# 1968 Corvette: Chevrolet Engineering Memo: Window Service Update

**Subject:** Window Service Update  
**Model and Year:** 1968 Corvette  
**Source:** Chevrolet Engineering Memo - Mr. G. H. Tyler of Chevrolet Engineering  
**Page Number:** NA  
**Date:** March 1968

MISC . Information from Mr. G. H. Tyler of Chevrolet Engineering

### GLASS ADJUSTMENT PROCEDURE

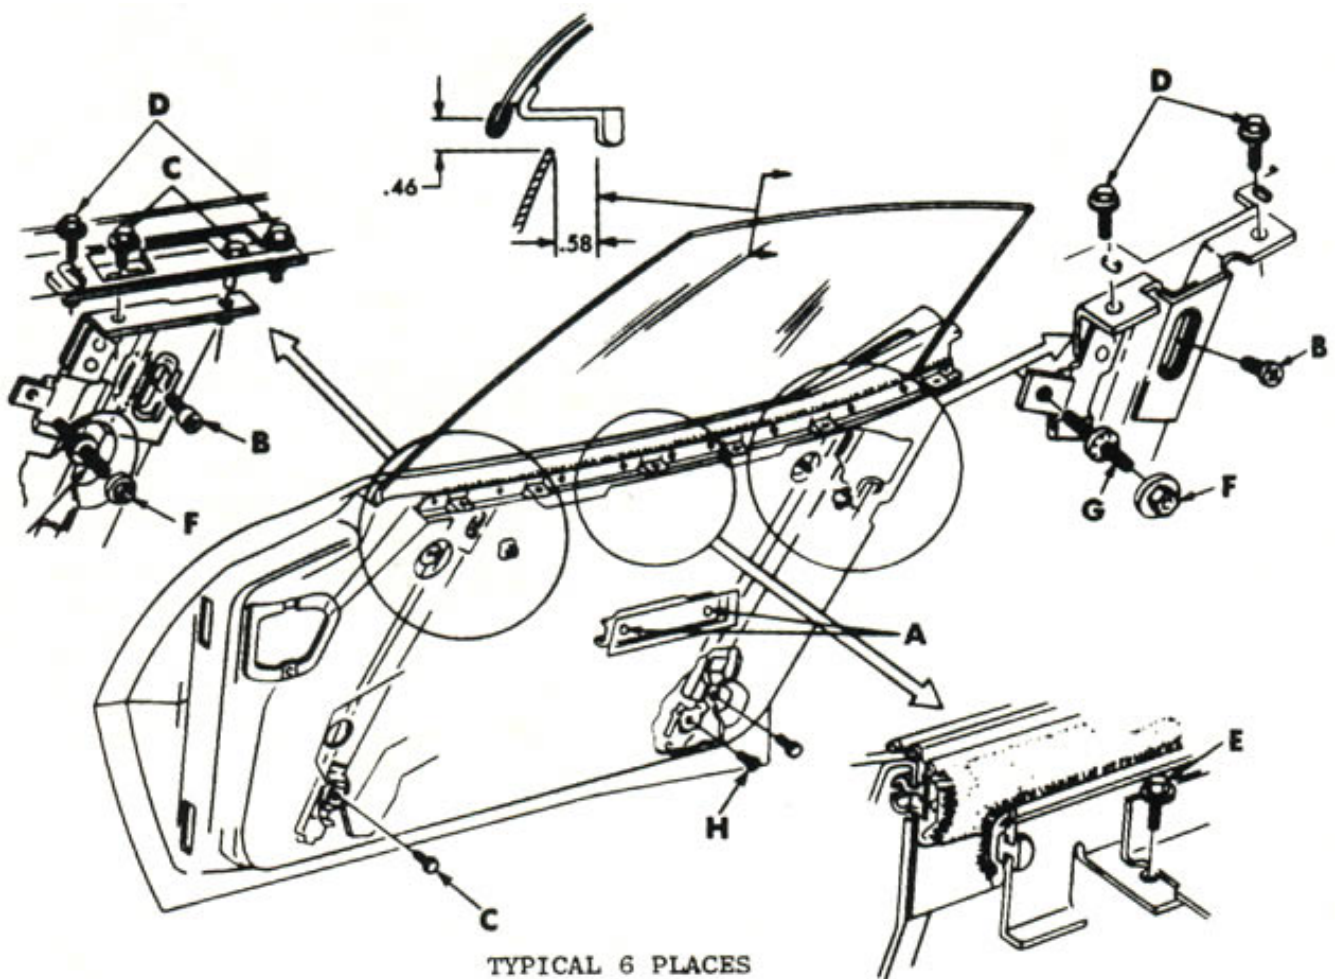
The adjustment procedure for 1968 Corvette door window glass has been revised as of this date. Items No. 3 and 4 have been revised.

1. Loosen bolts (A) and adjust the fore and aft tilt of the door window glass by rotating until a constant gap, or relationship, is obtained between the front edge of glass and the windshield pillar. Retighten bolts (A).
2. Loosen the front and rear stop screws (B) and roll glass up until top edge is .46 below roof rail. Move front and rear stops to contact the window rollers. Retighten screws (B).
3. Loosen the 3 bolts (C) and front nut (F) and slide door glass forward so that the front edge is .44 from and parallel to the windshield pillar. Retighten bolts (C).
4. Loosen bolts (D), (E) and rear nut (F). move bailey weatherstrip outboard so outer nylon pads are in contact with door outer panel reinforcement. Retighten bolts (E). move glass run channel so the top

of the glass is .58 from the vertical flange of the roof rail (move the glass run channel outboard to move the upper edge of glass inboard, move the glass run channel inboard to move the upper edge of glass outboard.) Retighten bolts (D).

5. Turn adjusting screw (G) so the front and rear inner nylon pads are in light contact with the wedges. Tighten nuts (F).
6. Loosen screw (H) and roll glass down until top edge is flush with door outer panel. Move stop to contact the window roller. Retighten screw (H).
7. Install and adjust windshield pillar weatherstrip, front rail weatherstrip, center rail weatherstrip, and rear rail weatherstrip to seal on glass.

Above procedure pertains to Assembly Plant operation. For Service, remove weatherstrip, weatherstrip retainer and door trim panel prior to glass adjustment.
